CITY OF JOPLIN
Senior Center-Meals On Wheels
Zone Improvement Project
CDBG-DR GRANT
No. B-12-MT-29-0001

Addendum No. 3

Addendum No. 3

PROJECT NO: A17-0642 DRAWN BY: ARF DATE: 01/19/2021	JOPLIN SENIOR CENTER DUMPSTER ENCLOSURE	olsson 702 S. Main Street Joplin, MO 64801 TEL 417.781.0643	EXHIBIT 1

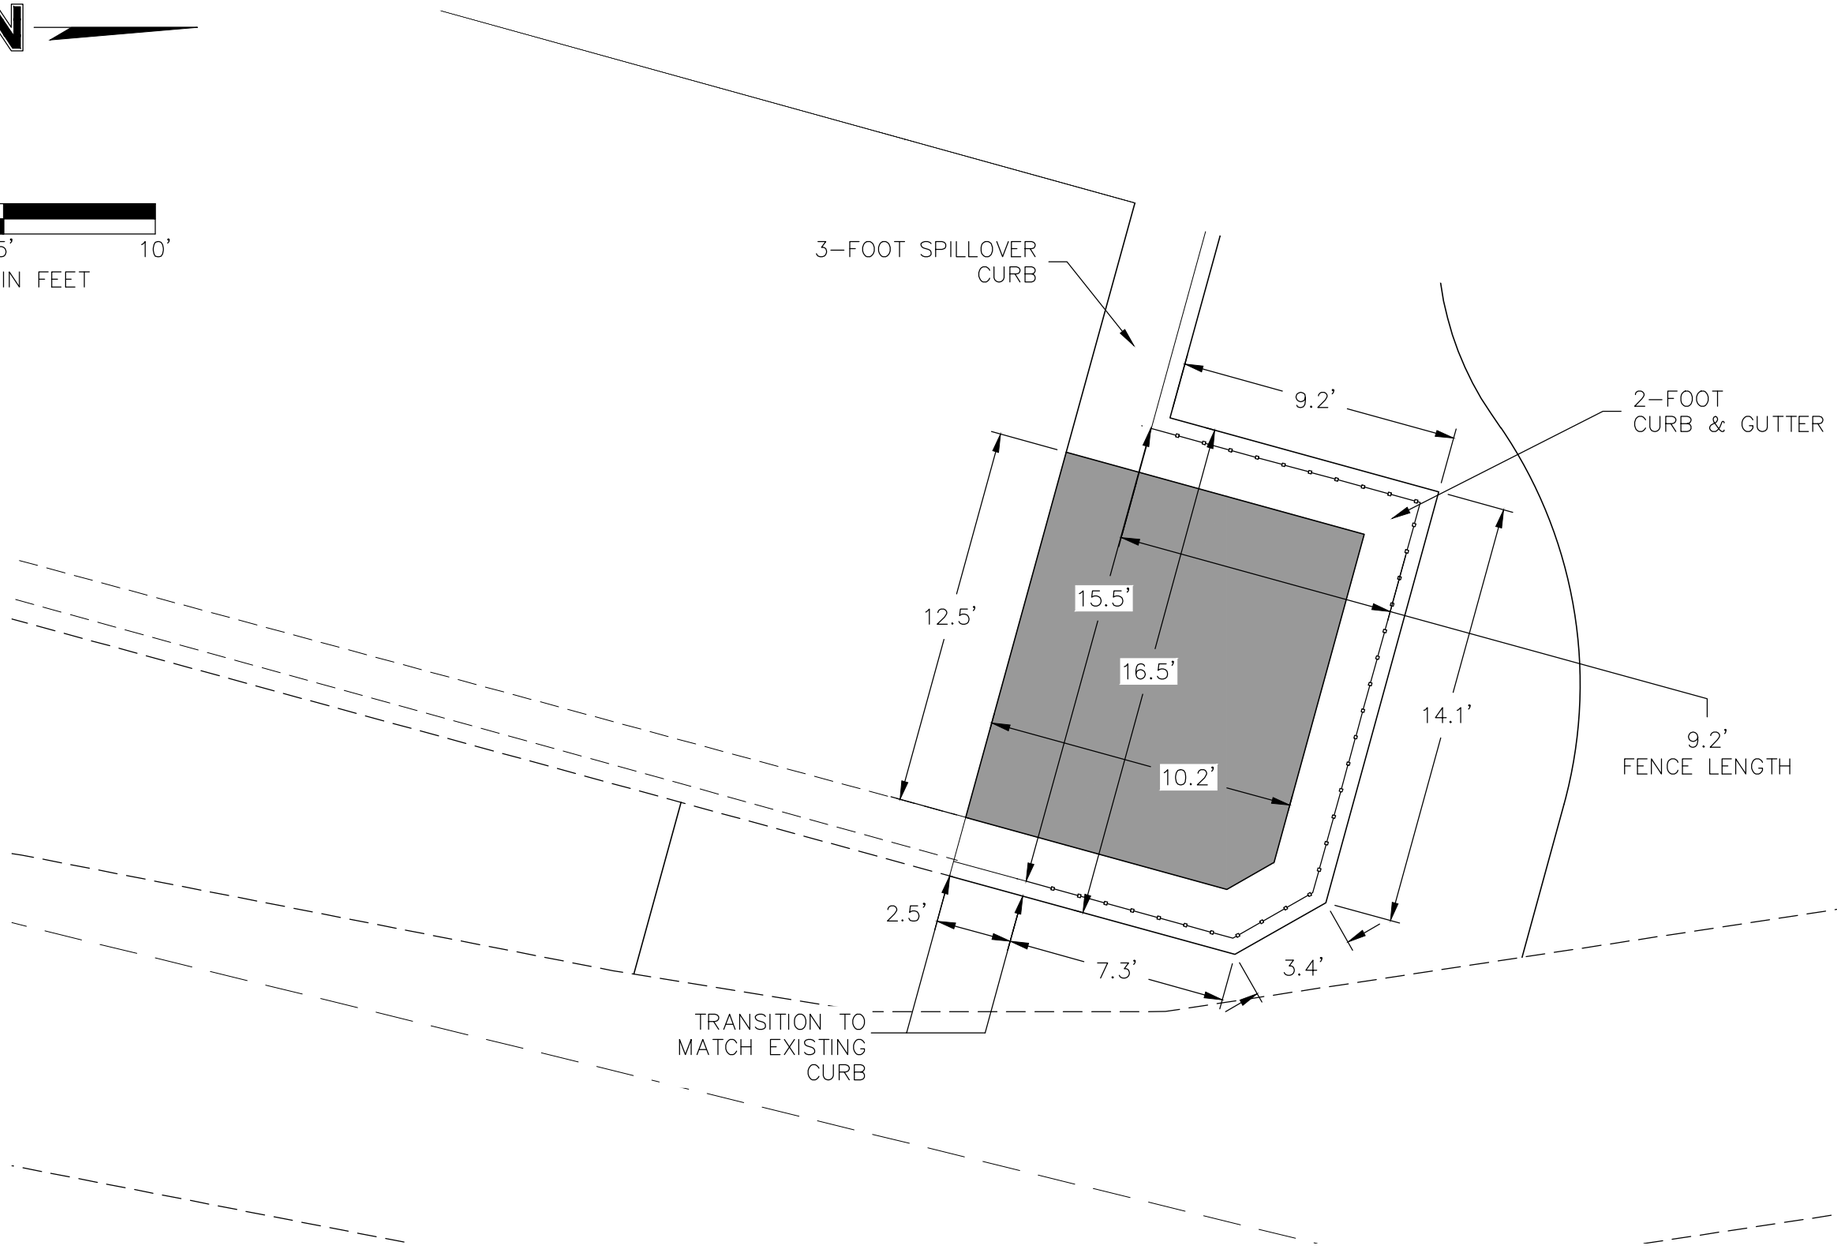
A supplemental plan sheet has been added to the plan set. The supplemental plan sheet clarifies the dimensions of the dumpster enclosure. Enclosure gates shall provide 15.5' of clearance. The supplemental sheet for the dumpster enclosure is attached.
